WCAP-15981-NP, Rev 0 (Non-Proprietary)  
Project No. 694

Subject: Pressurized Water Reactor Owners Group

**Responses to the NRC Request for Additional Information (RAI) Regarding the Review of WCAP-15981-NP, "Post Accident Monitoring Instrumentation Re-Definition for Westinghouse NSSS Plants," (LSC-0072 R1/MUHP-3038)**

**Response to Request for Additional Information Regarding WCAP-15981,  
“Post Accident Monitoring Instrumentation Re-Definition for  
Westinghouse NSSS Plants”**

**Figure 2 Process to Determine PAM Instrumentation That Should Be Included in the PAM Technical Specification**

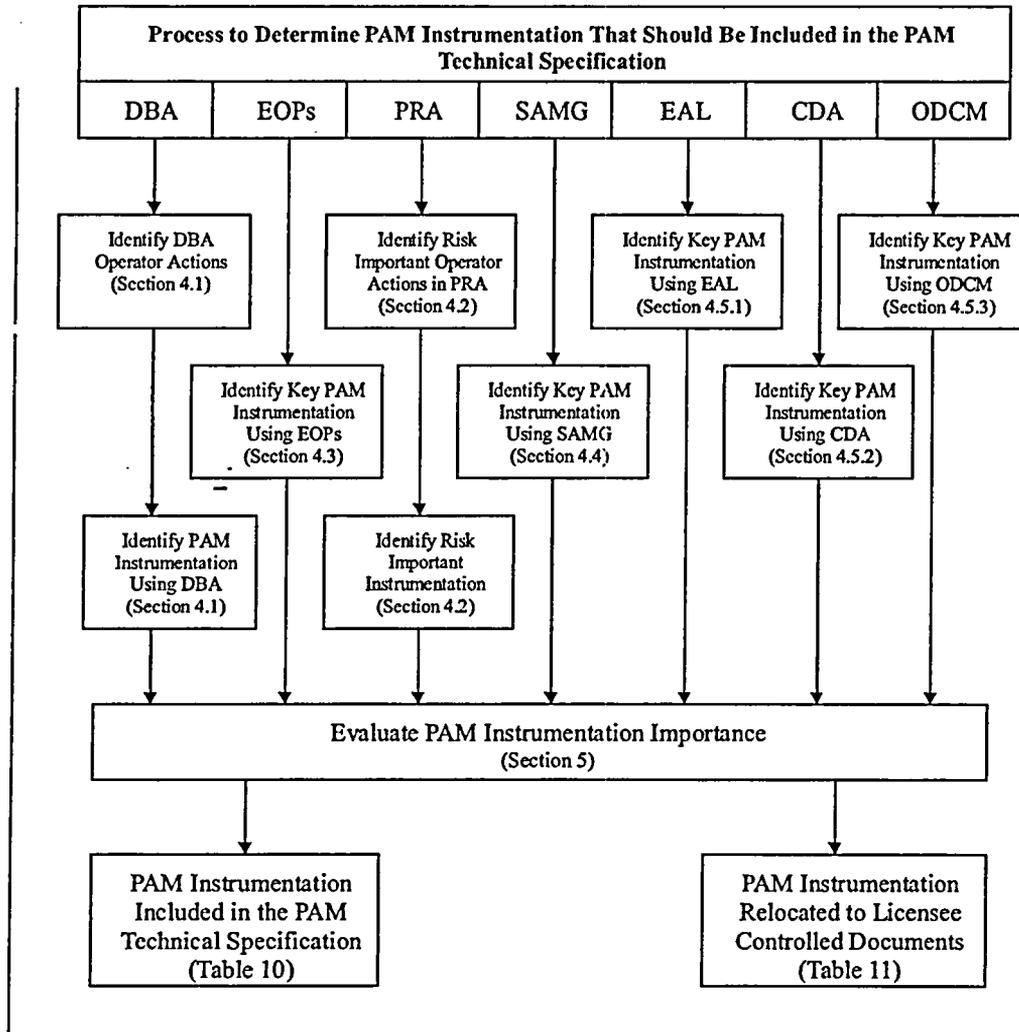
12. Please provide a flowchart or logic diagram depicting the process that a utility would be expected to follow to determine whether a specific instrument should be included in the PAM technical specification or licensee controlled documents. Important considerations within the process should include: (1) how the instrument relates to Criterion 3 and 4 of 10 CFR 50.36 (c)(2)(ii), (2) whether the instrument supports important operator actions in the plant-specific internal events PRA, external events risk assessment, and shutdown risk assessment, (3) whether the instrument is important for other purposes, such as EOPs, EALs, etc. (if this is in fact a consideration in the decision), (4) how the instrument would be classified using the RG 1.97 classification approach (if this is in fact a consideration in the decision), and (5) whether alternate indications are available in lieu of the specific instrument (if this is in fact a consideration in the decision). The flowchart should also depict the process that a utility would be expected to follow to: (1) confirm that the plant-specific risk models (for internal events, external events, and shutdown events) are of suitable quality for this application (i.e., peer review findings that could impact the identification and ranking of important operator actions and associated instrumentation have been resolved), (2) confirm that the plant-specific risk models are of sufficient detail to reflect the risk significance of the specific operator actions and instruments, and (3) document the results of the risk evaluation.

Section 8 was revised to identify the details of a plant specific PAM instrumentation evaluation by adding a flowchart that illustrates the process that a licensee would use to determine whether a specific instrument should be included in the PAM Technical Specification or relocated to a licensee controlled document.

A flowchart that illustrates the process that a licensee would use to determine whether a specific instrument should be included in the PAM Technical Specification or relocated to a licensee controlled document was provided in the revised Section 8.

The overall process to be used by licensees to identify the PAM instrumentation that should be included in the Technical Specifications is provided in Figure 2. This process is identical to that described in this report, except that plant specific information would be used in place of generic information.
